DESIGN RECOMMENDATION MEETING

9201 Delridge Way SW
Seattle, WA 98106

3029353, 3029353-EG

2/21/19

17.0 DEPARTURE 1

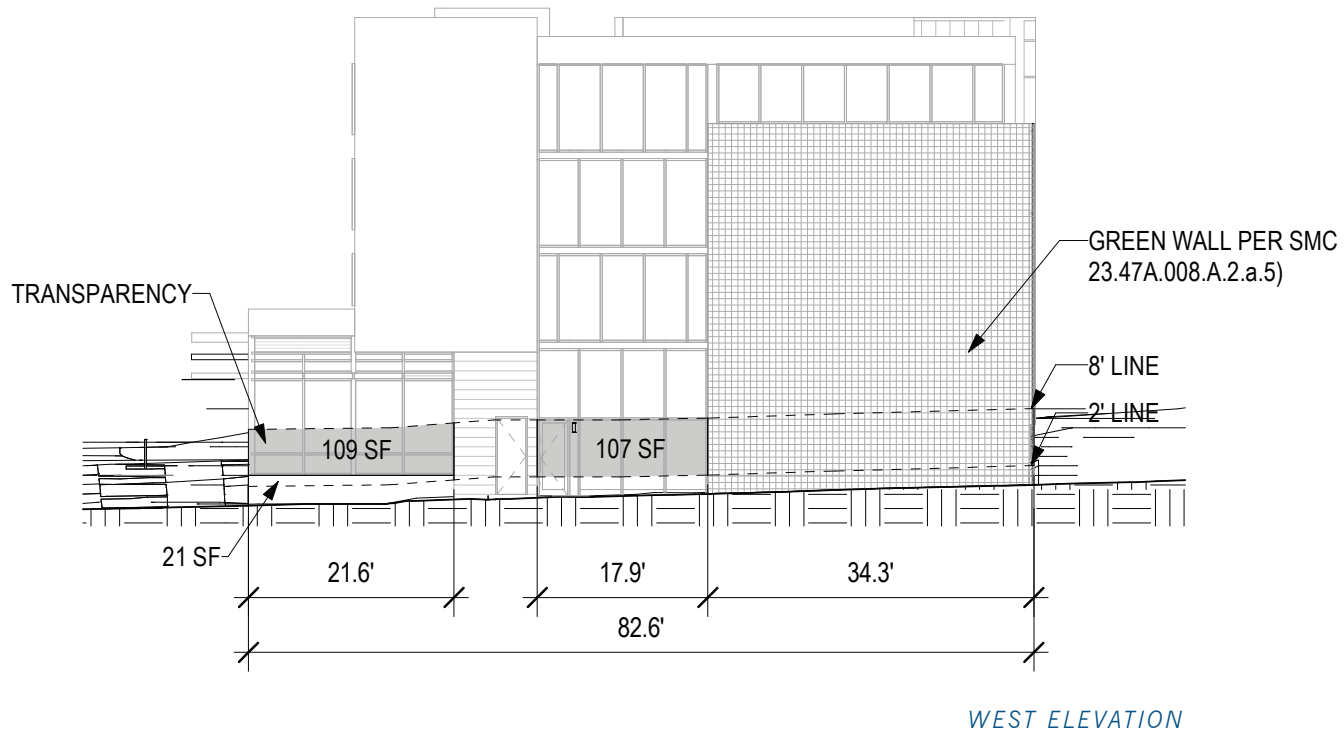
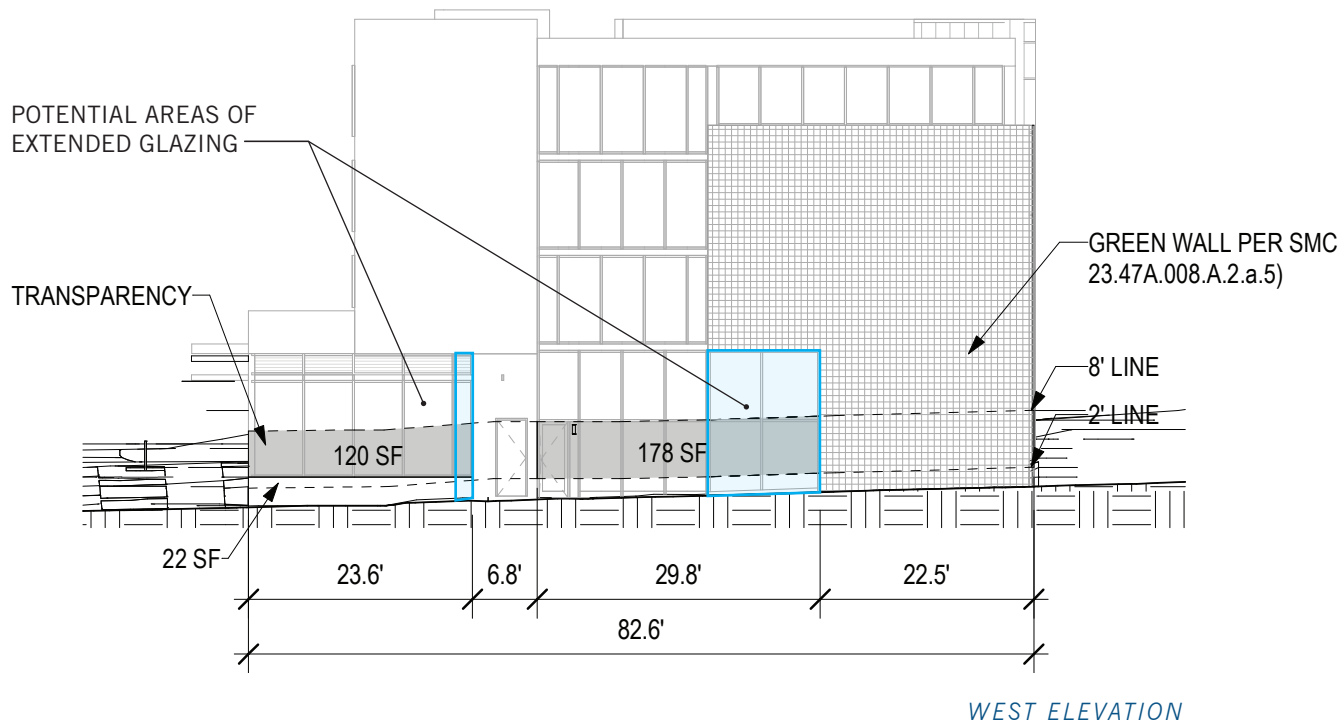
CODE CITATION:	23.47A.008.B.2.a
CODE REQUIREMENT:	60% of the street-facing facade between 2 feet and 8 feet above sidewalk shall be transparent.
CORRESPONDING DESIGN GUIDELINE:	PL3 - Street-Level Interaction: Encourage human interaction and activity at the street level with clear connections to building entries and edges.
PROPOSED DESIGN DEPARTURE:	33% transparency is proposed at street-level between 2' and 8' above grade for the 20th Avenue SW facade.
RATIONALE:	20th Avenue SW is residential in nature and doesn't have a largely active street life. As such, a green wall system along a large portion of the street is more preferable than windows and qualifies as a non-blank facade. The proposed green wall was also supported by neighborhood attendees through voluntary community outreach.

20TH AVENUE SW:
TOTAL TRANSPARENT FACADE AREA BETWEEN 2 FEET AND 8 FEET: 161 SF
 $((21.6 \times 6 - 21) + (17.9 \times 6)) / (82.6 \times 6) = 0.44$
 $0.44 \times 100 = 44\% < 60\%$ (NOT COMPLIANT, DEPARTURE REQUESTED)

20TH AVENUE SW:
TOTAL TRANSPARENT FACADE AREA BETWEEN 2 FEET AND 8 FEET: 298 SF
 $((23.6 \times 6 - 22) + (29.8 \times 6)) / (82.6 \times 6) = 0.61$
 $0.60 \times 100 = 60\%$ (COMPLIANT)
